CITY OF KYLE

ADDENDUM NO. 1

Request for Qualifications (RFQ) Project Management Services “K20-21.10”

June 10, 2021

Addendum No. 1 - Attachment A

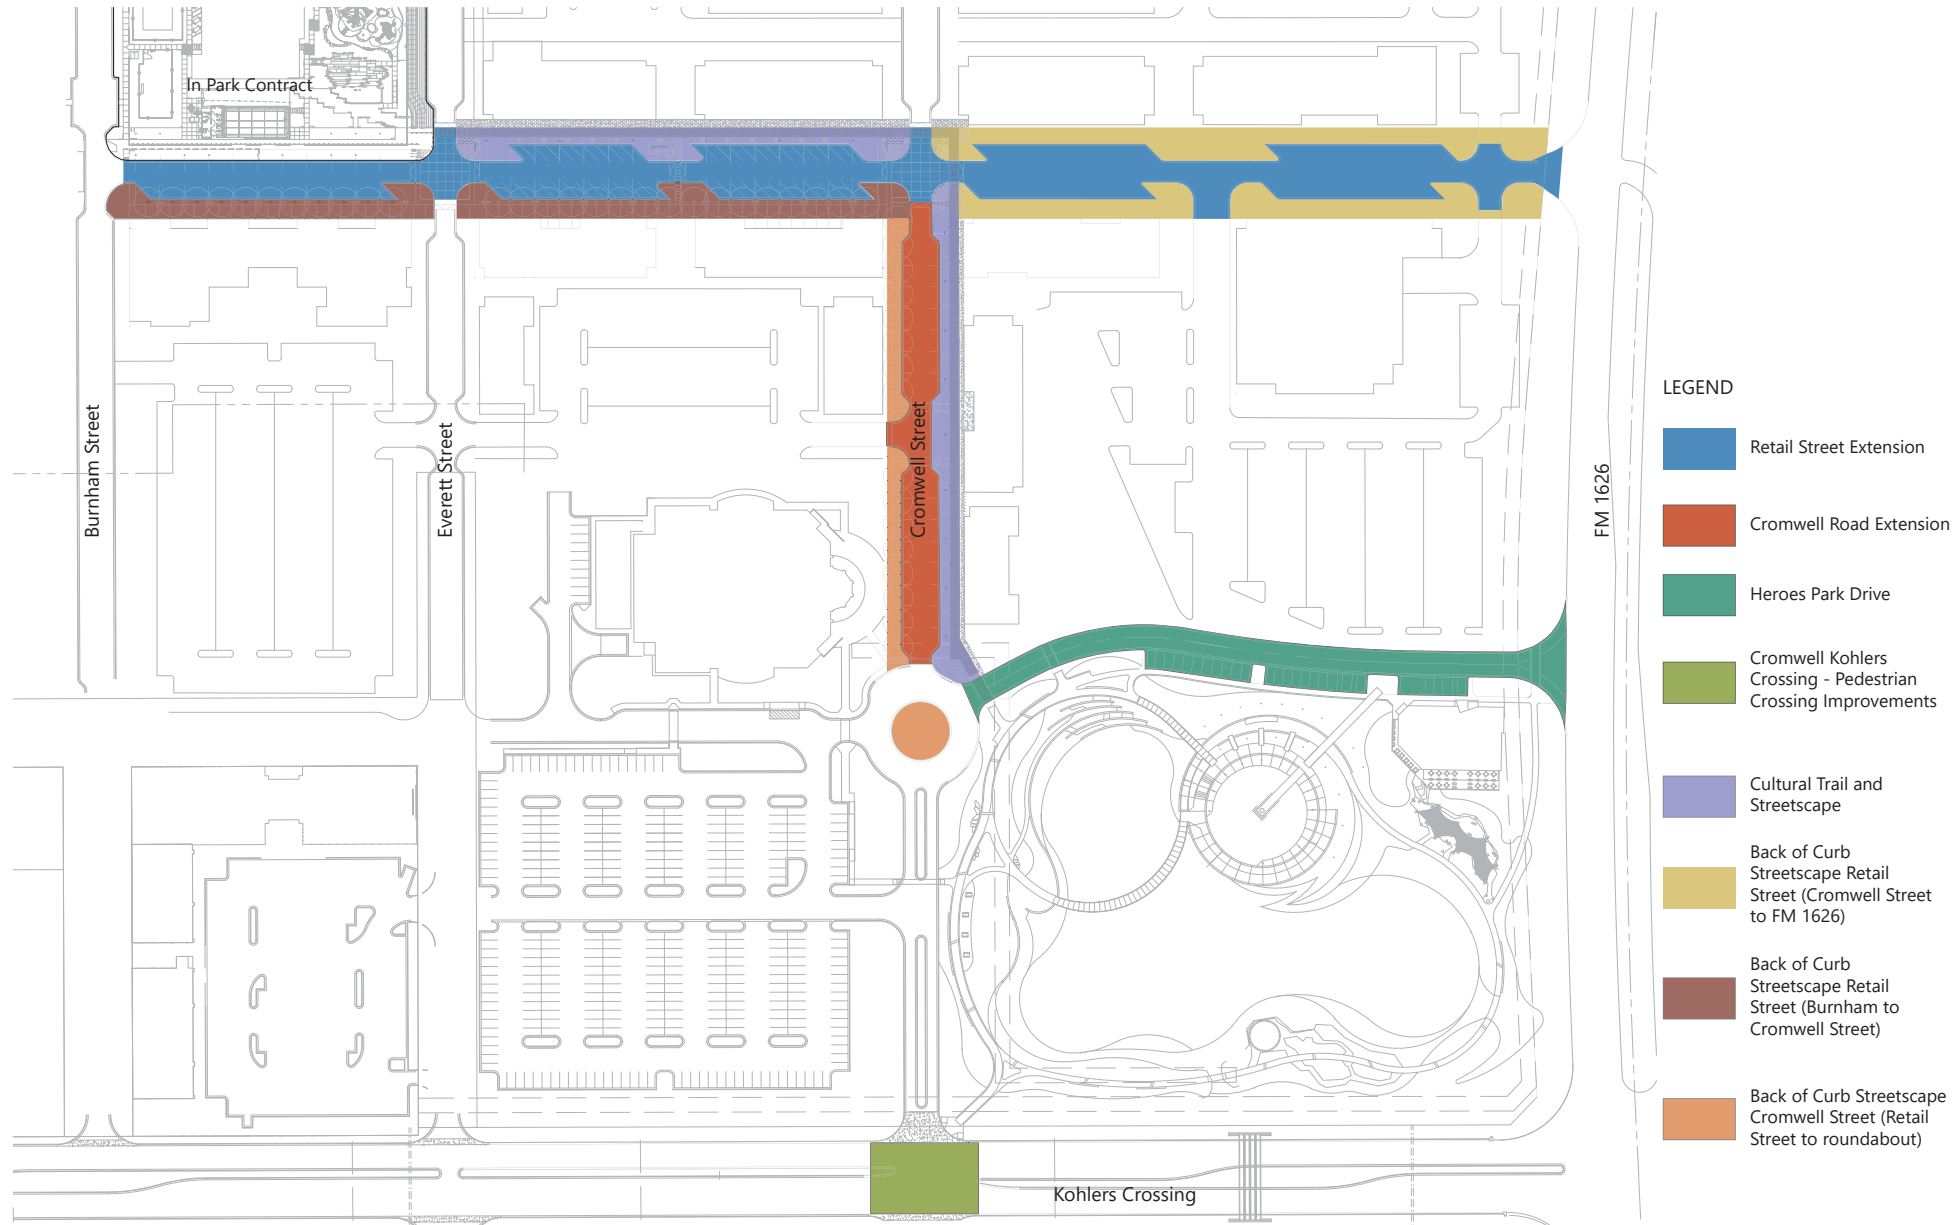
Q7: Can more information be provided regarding the location / limits of the following two roadways?

- Heroes Memorial Drive
- Brick and Mortar Street

Attachment A to this addendum is the latest sketch of the roads to be constructed by the city. The city's investment will only cover the cost of curb-to-curb improvements.
